Our Ref.: 5964/003/002

Re: RESPONSE TO LLFA COMMENTS ON RESERVED MATTERS APPLICATION FOR THE LAYOUT, SCALE, APPEARANCE AND LANDSCAPING OF 93 DWELLINGS PURSUANT TO OUTLINE PLANNING PERMISSION P/21/1260/2 (OUTLINE APPLICATION FOR UP TO 93 DWELLINGS)

The LLFA's comments, together with the corresponding designer responses, are provided below:

Photo 1. Existing Hedwall – North-Eastern Outlet

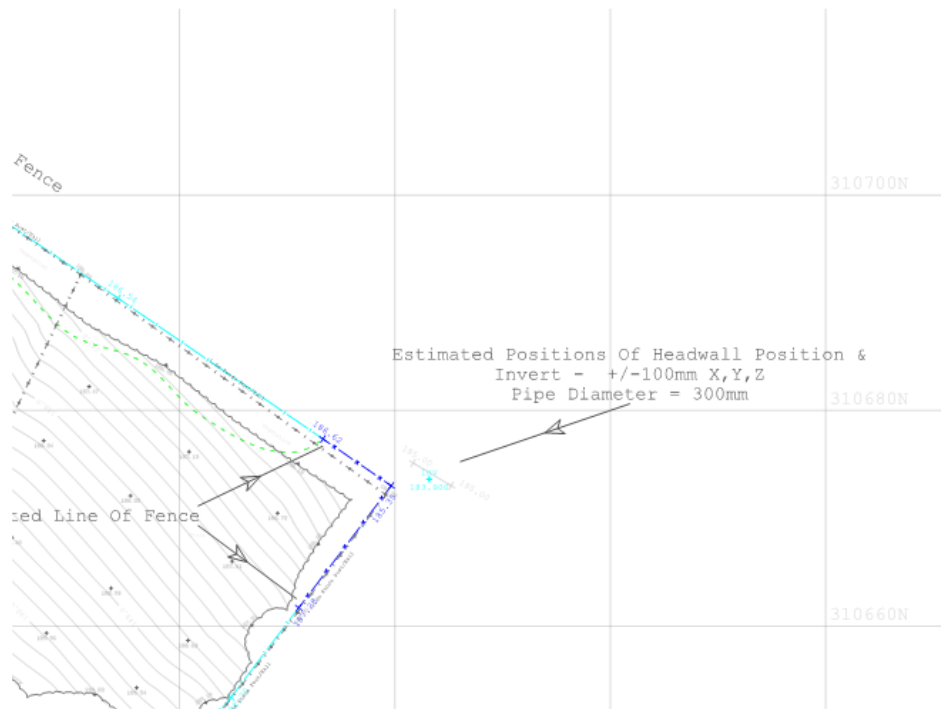
It appears that there are two watercourses/ditches on site which will be removed as part of the development layout. Given that this reserved matters application will fix the layout for the site further information is required on these ditches and the impact removing them will have. The documents suggest that the upstream connectivity of the ditches is still to be confirmed. Whilst Land Drainage Consent is not required at this stage prior to approval of reserved matters, the LLFA do need to understand that the removal of the ditches is appropriate and that consent is likely to be granted. The applicant should also note Leicestershire County Council's culverting policy (available online) which requires open watercourses/ditches to be retained and culverted only when it is clearly demonstrated to be necessary. Retained open watercourses/ditches must include space for maintenance access. Leicestershire County Council as the LLFA advises the LPA that the application documents as submitted are insufficient for the LLFA to provide a substantive response at this stage. In order to provide a substantive response, the following information is required:

- *Confirmation of contributing area, proposed discharge rate and required storage volume.*
- *Information on the upstream connectivity of the ditches proposed to be removed, and confirmation that conversations regarding Land Drainage Consent have begun (note the LCC culvert policy)*

It should be noted that, although the start and end points of the existing ditches are heavily overgrown, no positive inlet or outlet pipes were identified during the walkover. The existing ditch running across the centre of the site is, at its eastern end, fully overgrown and silted. It is therefore presumed that this ditch was historically connected to the existing ditch along the eastern boundary, which subsequently discharges into the existing headwall located beyond the site redline boundary, see photograph below:

Both the north-eastern and northern outlet pipes have been identified on the topographical survey.

Drawing Title
PROPOSED IMPERMEABLE AREA PLAN
SHEET 1 OF 3

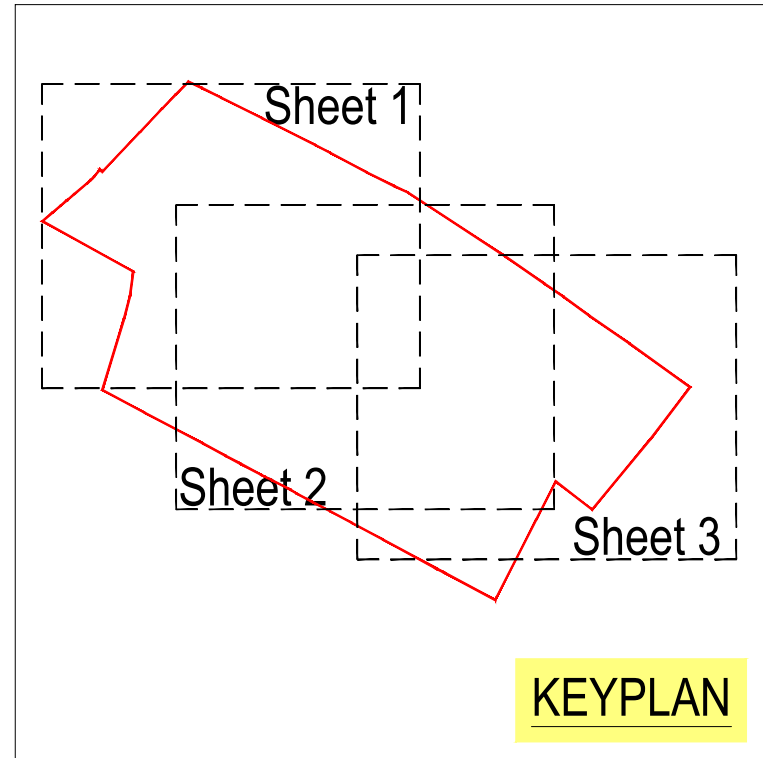
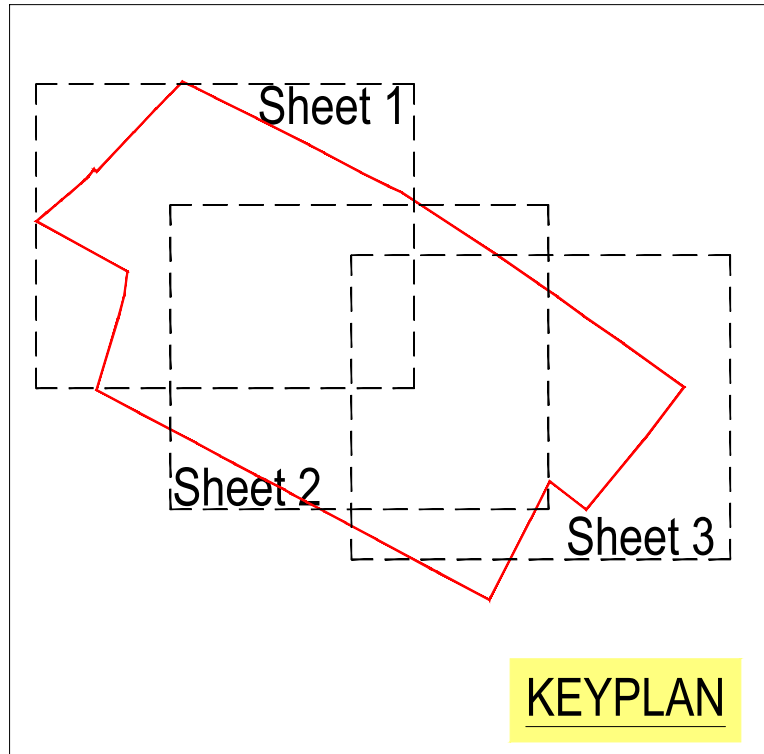
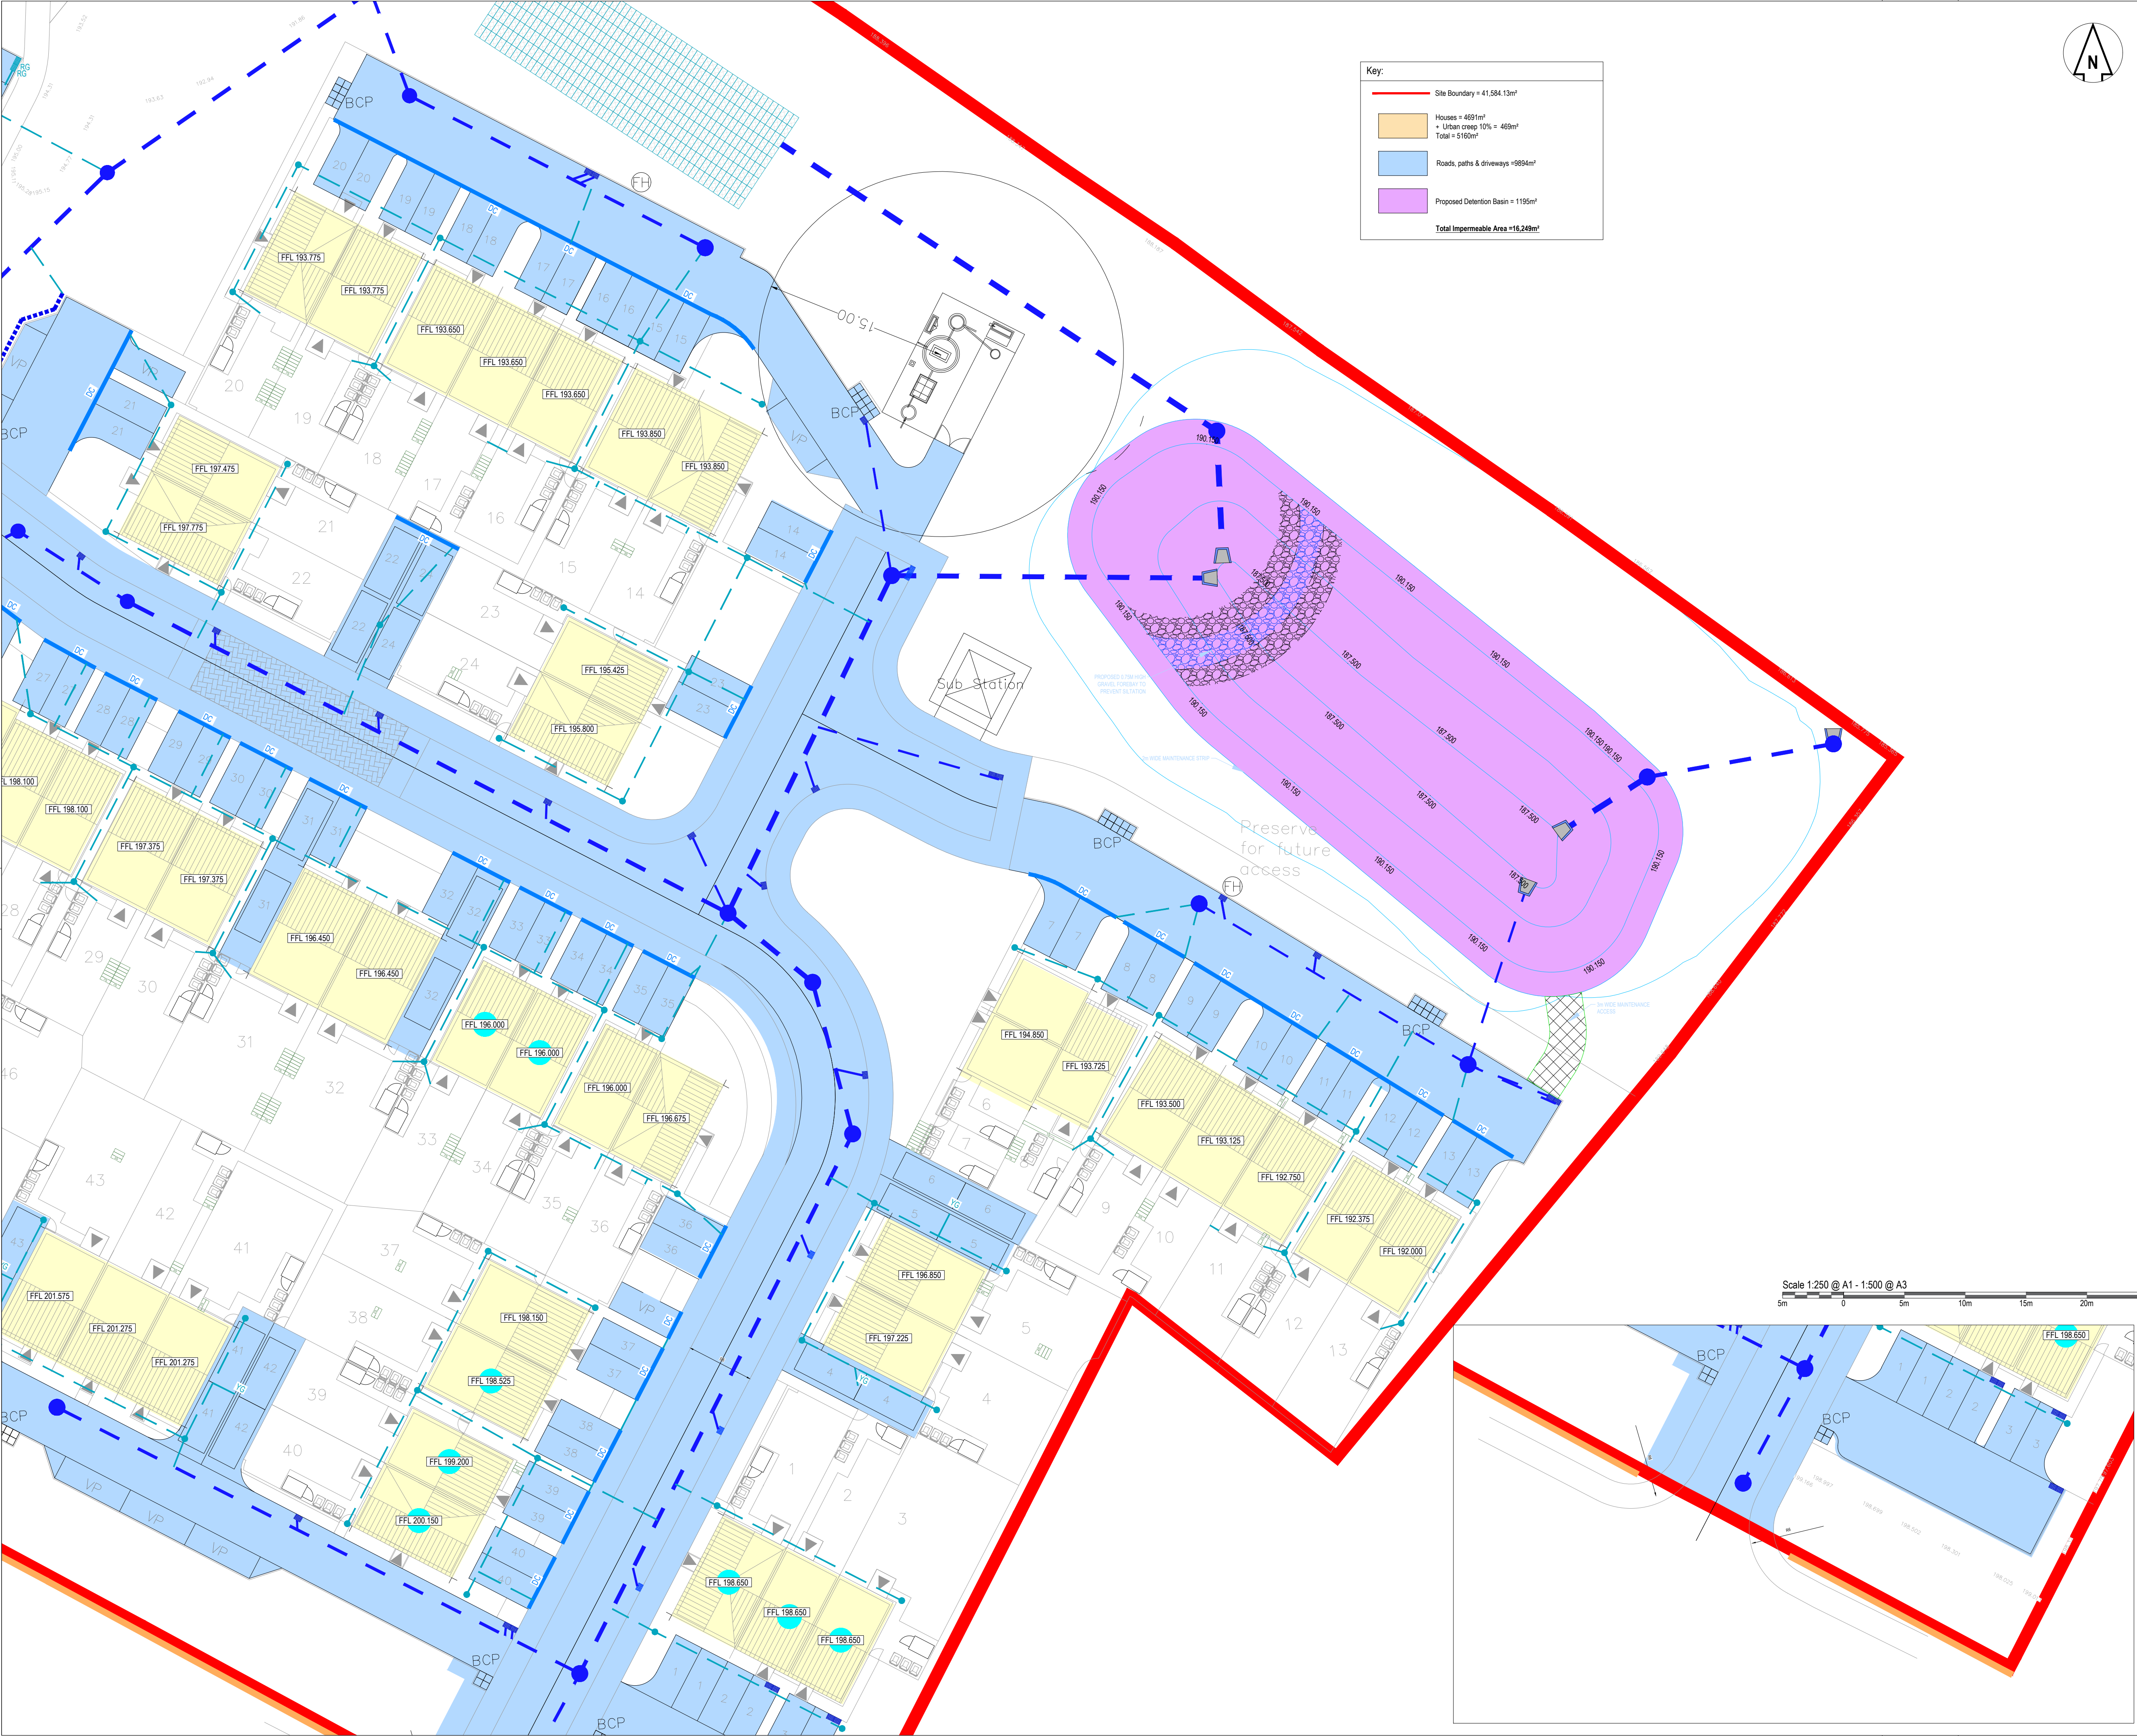
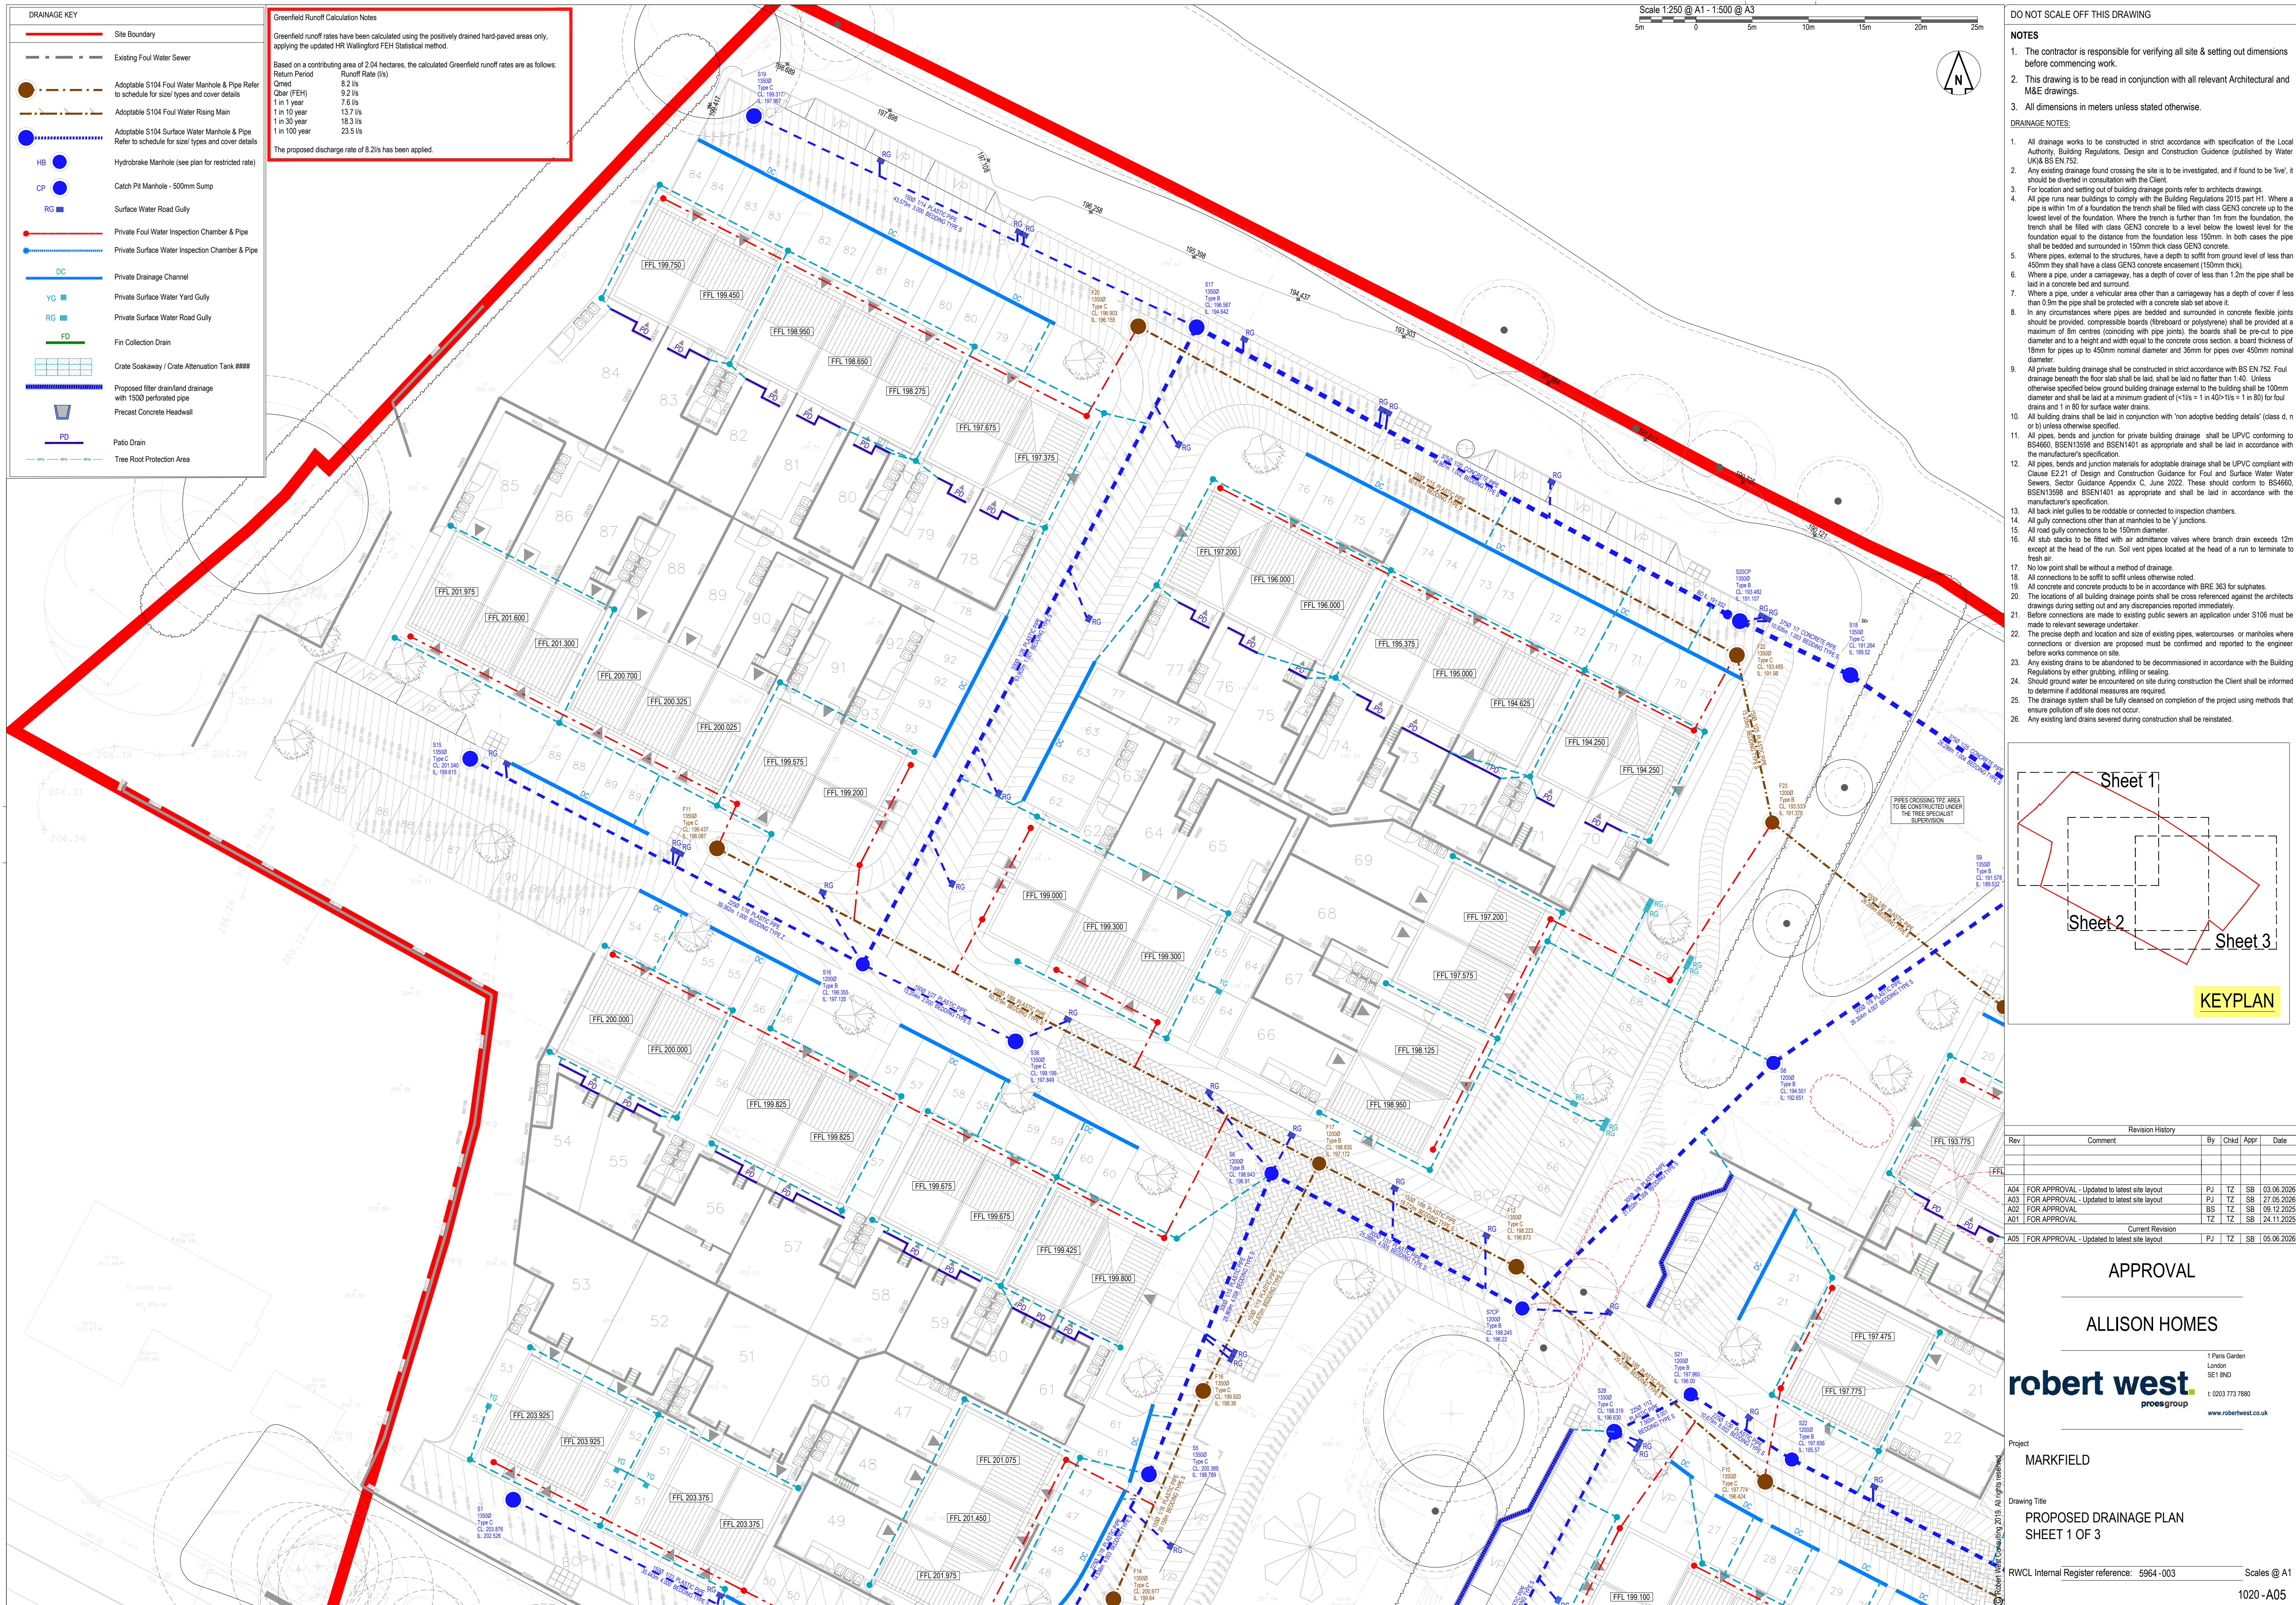
It is not clear where the contributing area figure has been calculated from. Section 3.3 of the technical note and the impermeable area both suggest an area of 1.541ha. However, it seems the drainage plan is using an area of 2.04ha. Clarification of the contributing, the proposed discharge rate and volume of storage required, with documents updated as necessary. The discharge rate should be based on the contributing catchment only. Calculations and supporting plans should be submitted to support the QMED/QBAR rate.

The existing Greenfield runoff has been calculated using the HR Wallingford Greenfield Runoff Estimation Tool, based on FEH data and the contributing areas as indicated in drawing numbers 5964-003-1060 – 1062.

The contributing catchment area includes only impermeable hardstanding and roof surfaces. Surface water runoff from these areas will be captured by the proposed on-site drainage network, attenuated within the on-site storage system, and subsequently discharged to the existing watercourse at a controlled rate.
